E5515B-09B

S E R V I C E N O T E

E5515B Wireless Communications Test Set (8960 Series)

Boot Up Failures at Power-On Require Replacement of 10 GB Hard Disk Drive (HDD)

Figure 1 – HDD failure during test set power-on (BSP code not loaded from HDD to RAM).

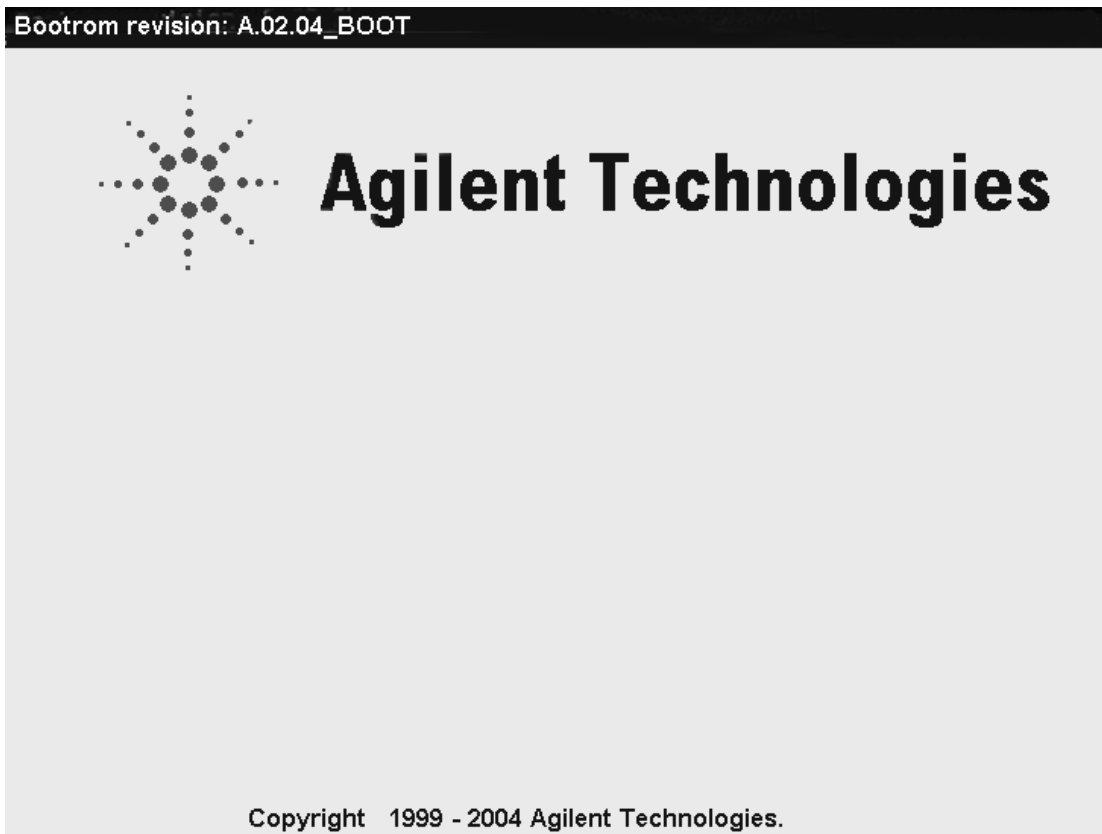
- **Figure 1** shows the typical point in the test set bootup process where the HDD fails to initialize. Note that the BSP Revision code is not displayed in the upper right corner of the display. A typical failing 10 GB HDD will show this screen intermittently in the first stages of failure.

A defective Channel Control chip on the HDD control circuitry is the main source of failures. This chip controls the read/write function to and from the HDD. The failure mechanism is accelerated with elevated ambient temperature and humidity (above 80 deg F and 80% relative humidity). Replacement HDDs (20 GB) have been re-designed to correct this problem.

If the test set fails to bootup correctly replace the HDD using repair kit E5515-61833 (which uses a 20 GB HDD). You must provide the model number and serial number of the test set when placing an order for this repair kit.
